RECREATIONAL VEHICLE
SAFETY RECALL NOTICE

Safety Recall: 23V-822

IMPORTANT SAFETY RECALL – 2nd Notice

Figure 1

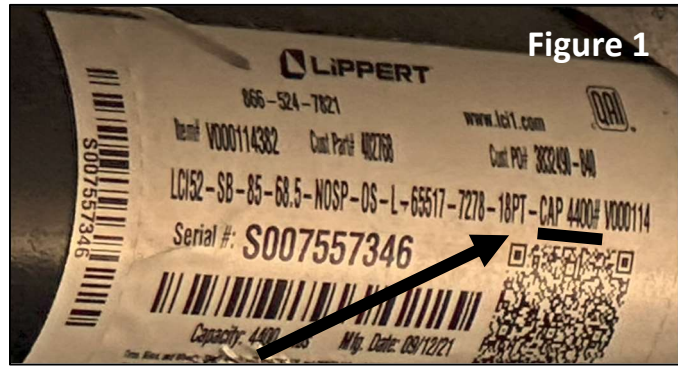
It has been decided that the vehicles in the recall population may have axle springs rated at 4400 pounds rather than the 5100 pound axle rating as specified on Federal Identification Tag. The axles installed had the wrong size springs. Under certain conditions during travel, undersized axle springs can be overloaded leading to an increased risk of axle spring failure and increasing the risk of a crash.

You may choose to self-inspect the axle's tags. If the tag reads as CAP 4400#, as shown in Figure 1, as soon as possible, please make an appointment to have your RV serviced by your dealership. Customers should unload all cargo and empty holding tanks (fresh water, grey water, black water, and water heater) and take their unit to an authorized dealer for remedy of the incorrectly installed axles springs. The labor

Keystone representatives have been in contact with the staff at your selling dealership regarding this situation. The remedy is to replace under rated 4400 LB springs with the correct size 5100 LB springs. This would require both 2200 LB springs be replaced. The service and parts required for this corrective action will be provided at no charge to you.
